UNITED STATES PATENT AND TRADEMARK OFFICE

APPLICATION NO.	FILING DATE	FIRST NAMED INVENTOR	ATTORNEY DOCKET NO.	CONFIRMATION NO.
09/516,655	03/01/2000	Thomas C. Thompson		3209
7590	02/18/2004		EXAMINER	
Thomas C Thompson 92-543 Kokole PLace Makakilo, HI 96707			GARCIA, ERNESTO	
			ART UNIT	PAPER NUMBER
			3679

DETAILED ACTION

Claims 1 and 3-7 are rejected under 35 U.S.C. 102(b) as being anticipated by Way, Sr., 5,813,173 (see marked-up attachments).

Fig. 4

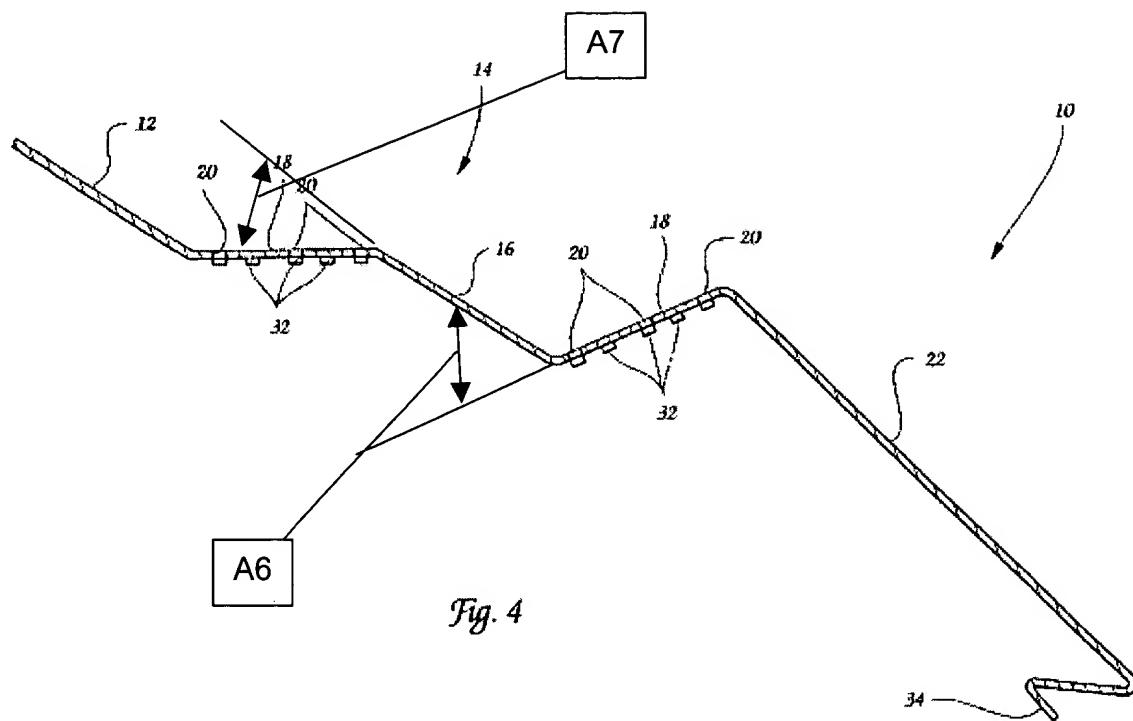
Regarding claim 1, Way, Sr. discloses in Figures 3, 4 and 6 a unitary connector comprising a base web **18** (the right one in Fig. 4), offset, angled, blocking webs **A2** (Fig. 3), and an offset web **16**. The blocking webs **A2** each have a generally right angled bend **A3** forming a rafter tab **A4** (Fig. 6). The base web **18** and each of the blocking webs **A2** is connected by the offset web **16**. The offset web **16** has a first acute angled bend **A6** attached to the base web **18** and a second, unequal, acute angled bend **A7** attached to the blocking webs **A2**.

Regarding claim 3, the offset web **16** is connected to the base web **18** by the first acute angled bend **A6** at an acute angle.

Regarding claim 4, the offset web **16** is connected to the blocking webs **A2** by the second, unequal, acute angled bend **A7** at an acute angle.

Regarding claim 5, the first acute angled bend **A6** and the second, unequal, acute angled bend **A7** are attached to opposite ends of the offset web **16**, having generally unequal acute bends in opposite directions, thereby offsetting the blocking webs **A2** at an acute angle from the base web **18** and avoiding frieze boards or blockings on a house.

Regarding claim 6, the first acute angled bend **A6**, the second, unequal, acute angled bend **A7**, and the offset web **16** forming the base web **18** and the blocking webs **A2** unparallel to each other. Thereby forming a buttress between a roof rafter and the wall with underlying structural members, thereby preventing the exterior wall from detaching from the roof.

Regarding claim 7, the blocking webs **A2** divide the blocking webs **A2** into generally equal left and right blocking webs **A2**.
